SYAMA PRASAD MOOKERJEE PORT, KOLKATA

Tender No. : SDM(P&E)/T/73/2020-2021

Supply, Installation, Testing and Commissioning of 3.3 kV HT Panel, 415 Volt LT Panels, 3.3 / 0.433 kV Transformers, 3.3 kV grade HT & 1.1 kV grade LT cabling work and other allied works for augmentation of Lock Sub-Station at Lock Entrance of Haldia Dock Complex, SMP, Kolkata.

ADDENDUM - V

DRAWING NO - 2
(FOR TENDER PURPOSE ONLY)

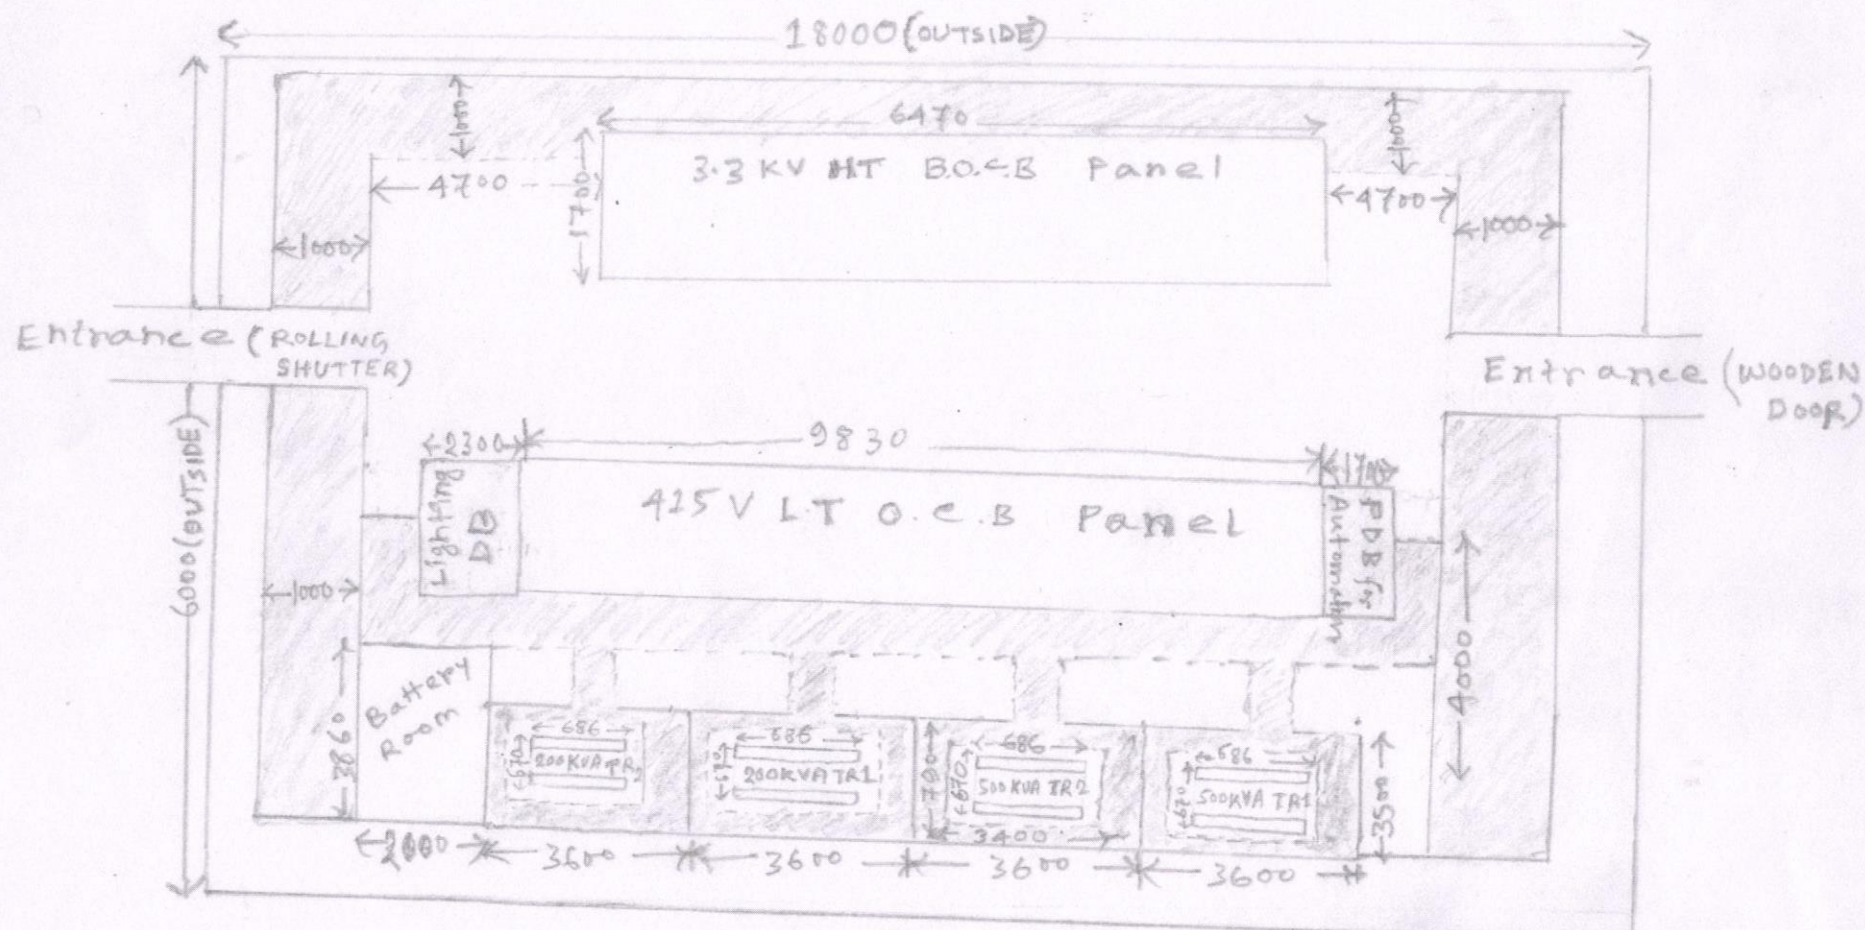
Sl. No.	Clause No/ Page No.	Tender Conditions	Queries of the firms	Clarifications of HDC, SMP, Kolkata
26	1 / 144	Civil work -BOQ	Provide drawing of cable trench	Tentative drawing of RCC cable trench is attached for reference only.
			Provide drawing/ design for 650 x 650 mm RCC cable trench	
			Civil Drawing for Massonary trench is not found	
	2 & 3 /144	Civil work - BOQ	Please confirm whether to apply any paint on joint / cutting and bending of G. I. Chequered Plate and G. I. Angle & Channel.	Provide M.S Chequered plate. Painting procedure as per IS (2C P + 1 IM +2C F). Thickness of MS Angles & MS Channels should not be less than 6 mm and as per direction of EIC, as per site requirement. Please see Addendum-V.
27	11 / 141, 12 / 142 & 14 / 142	Laying ,Testing and commissioning of HT/LT cable and end termination.	Laying, testing and commissioning from Substation to MH Houses etc. Job includes supply & installation of Hume Pipe and G.I. Pipe. Size and quantity of HT End termination for each size of cable may please be provided.	HT / LT cable shall be laid through Hume pipe/ GI pipe as directed by EIC for road crossing. Size of the HT / LT end termination based on the cable size mentioned in the BOQ. However, quantity of the straight through joint as per site requirement which is in the scope of the tender and as directed by EIC.

42.	144	1	Price schedule (Part-B)	<u>Civil work:</u> Construction of RCC cable trench with removable top cover size 650mmx650mm as per enclosed drgs. Quantity : 350 Mtrs.		<u>Civil works:</u> Construction of RCC cable trench of size 600 mm (W) X 900 mm (D) with removable top cover as per Technical Specification, latest relevant standards and attached Drawing No.2. Quantity : 500 Mtrs.
